Access Assessment Report

12 Boyle Street & 307 Sydney Road, Balgowlah

Report no. J1069-Access-2

Prepared by: Building Code Clarity Pty Ltd

Figure 1: Excerpt from Figure 29 of AS 1428.2 showing circulation space around bed

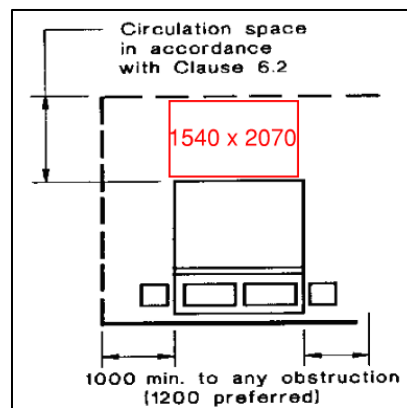
In each adaptable dwelling at least one bedroom must be sufficient area to accommodate queen size bed and wardrobe and circulation space requirements of AS 1428.2. AS 1428.2 requires 1 m clearance on both sides of a queen size bed (1530 x 2030 mm) and turning space (2070 x 1540 mm) at the base of the bed, with the required circulation space being clear of the wardrobe.

Figure 2: Markup of existing dwelling adaptable bedroom

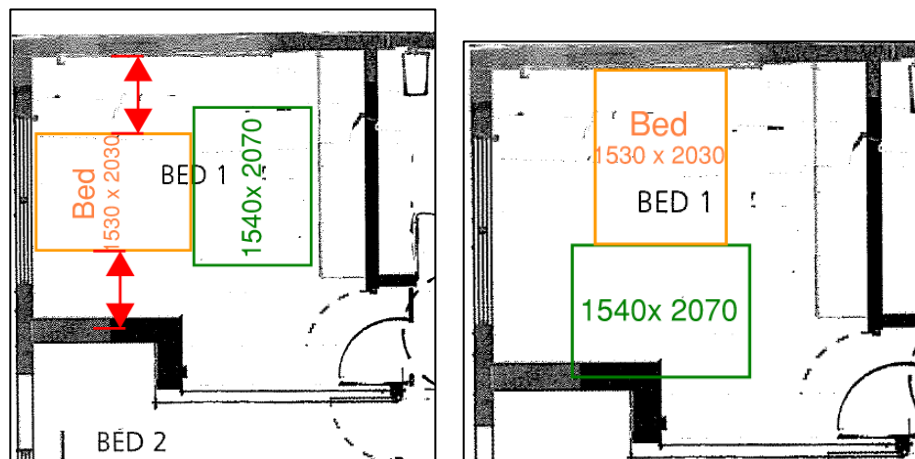
The adaptable bedroom of the existing dwelling does not appear large enough to accommodate the required circulation space. Adjustment to the existing wall between Bed 1 & Bed 2 may be required. Compliance to be detailed in the construction stage plans. The figures below show how the circulation space overlaps the existing wall in the two different bed orientations.
